UNITED STATES  
NUCLEAR REGULATORY COMMISSION  
WASHINGTON, D. C. 20555

The Commission has issued the enclosed Amendment No. 48 to Facility Operating License No. NPF-2 and Amendment No. 39 to NPF-8 for the Joseph M. Farley Nuclear Plant, Unit Nos. 1 and 2, respectively. The amendments consist of changes to the Technical Specifications in response to your application transmitted by letter dated March 1, 1984.

Joseph M. Farley Nuclear Plant  
Units 1 and 2

SAFETY EVALUATION BY THE OFFICE OF NUCLEAR REACTOR REGULATION  
RELATED TO AMENDMENT NO. 48 TO FACILITY OPERATING LICENSE NO. NPF-2  
AND AMENDMENT NO. 39 TO FACILITY OPERATING LICENSE NO. NPF-8

Figure 6.2-2 Facility Organization

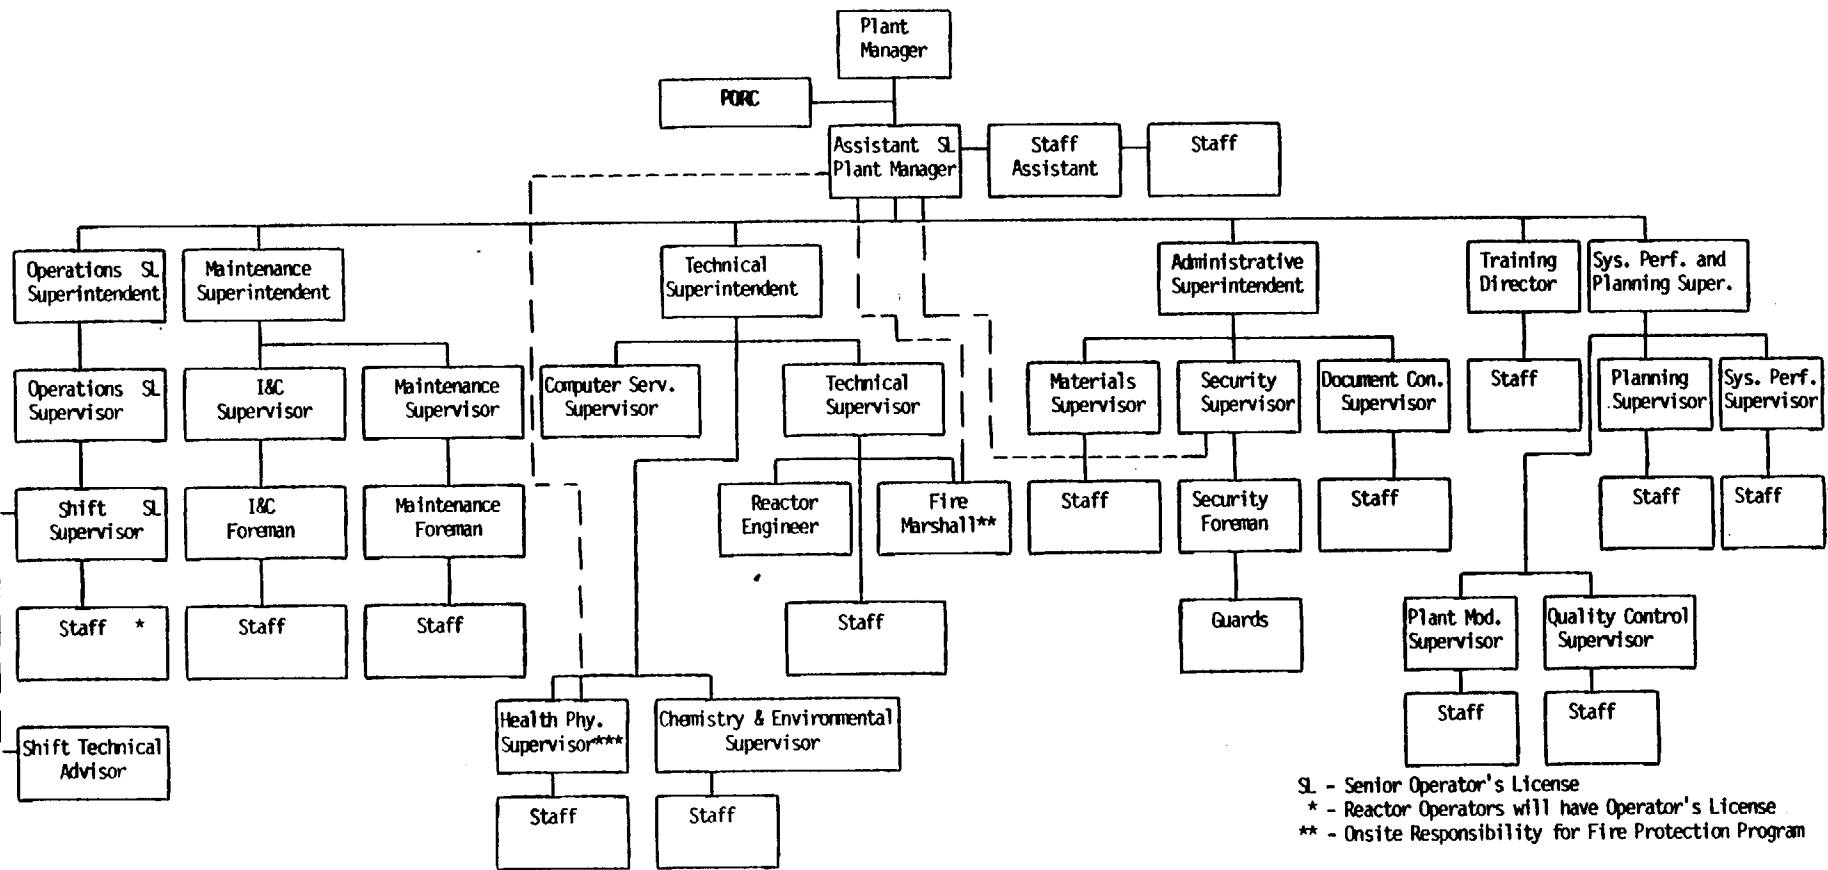
The amendments modify the Technical Specifications to correct errors in Table 4.3-1 (Units 1 and 2), Table 3.6-1 (Units 1 and 2), Table 3.6-1 Section D (Unit 1), and specification 3.7.11.1.c. Also Figure 6.2-2 (Units 1 and 2) is modified to reflect changes in the organizational chart changing the title of the chemistry supervisor and adding a computer services supervisor to the chart.

In their letter of March 1, 1984, APCo proposed several changes to the facility organization. The most significant of these were a change in the title of the Chemistry Supervisor to Chemistry and Environmental Supervisor; and the addition of a Computer Services Supervisor to the organization. No significant responsibility changes were associated with the Chemistry and Environmental Supervisor title change, rather the proposed title more closely reflects the responsibilities of the position. The addition of the Computer Services function reflects the importance the licensee places in this function in supporting the operation of the Farley Nuclear Plant.

Several other minor changes were made to the organization chart including the changes of the title of the Performance and Planning Superintendent to System Performance and Planning Superintendent; and the inclusion in the organization chart of staff personnel reporting to the Planning Supervisor, System Performance Supervisor, Plant Modifications Supervisor, and Quality Control Supervisor.

These proposed changes are purely administrative in nature and are acceptable.
